U.S. Department
of Transportation
**Federal Highway
Administration**

In Reply Refer To: HSSD/CC-88B

Name of devices: Sequential Kinking Terminal (SKT), and
Flared Energy Absorbing Terminal (FLEAT) with 2 Breakaway Posts
Type of devices: W-Beam Guardrail Terminals
Test Level: NCHRP Report 350 Test Level 3
Testing conducted by: Midwest Roadside Safety Facility
Date of request: April 22, 2008

Summary of Test Results and Sequential Photographs, Test No. FLT2P-1

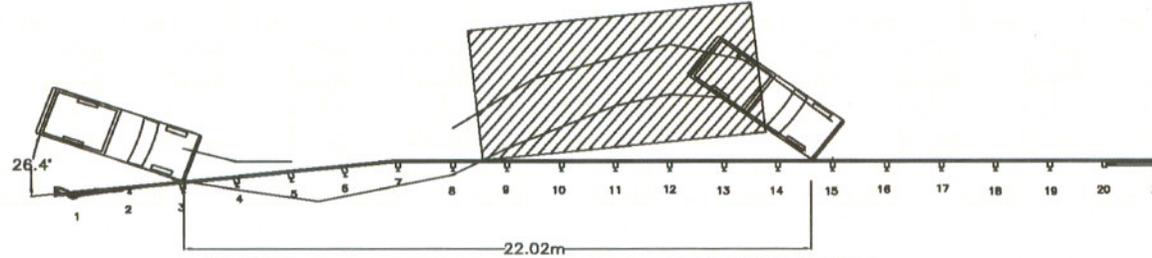
Test 3-35 examines the safety performance of the terminal for impacts at the beginning of the length-of-need. This test involves a 2000P striking at the beginning of length-of-need. The flare on the end of the FLEAT produces a more critical impact and this test should also be conducted on this terminal.

The test data summary sheets for the three recommended crash tests, FLT2P-1 (Test 3-35), FLT2P-2 (Test 3-34), and FLT2P-3 (Test 3-30) are enclosed for reference. In test FLT2P-3 there was a small hole in the floor pan caused when the nearly-stopped vehicle came to rest on the end of a guardrail post that was under the vehicle. We concur that this does not pose a significant risk to vehicle occupants. Otherwise, all occupant risk parameters of NCHRP Report 350 were within recommended guidelines. We concur that this testing shows acceptable performance for both FLEAT and SKT terminals when modified as described.

Summary of Test Results and Sequential Photographs, Test No. FLT2P-2

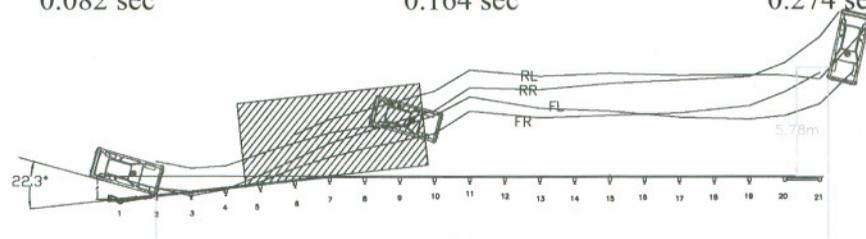
Test 3-34 involves an 820C vehicle striking the terminal at its critical impact point at a speed of 100 km/h and an angle of 15°. Because the vehicle can snag on posts 3 and 4 during this impact the new terminals need to be evaluated under this test condition. The flare of the FLEAT terminal effectively increases the impact angle for this test by approximately 6°. This test should be conducted. The increased effective impact angle makes testing of the FLEAT terminal more critical than a test of the SKT.
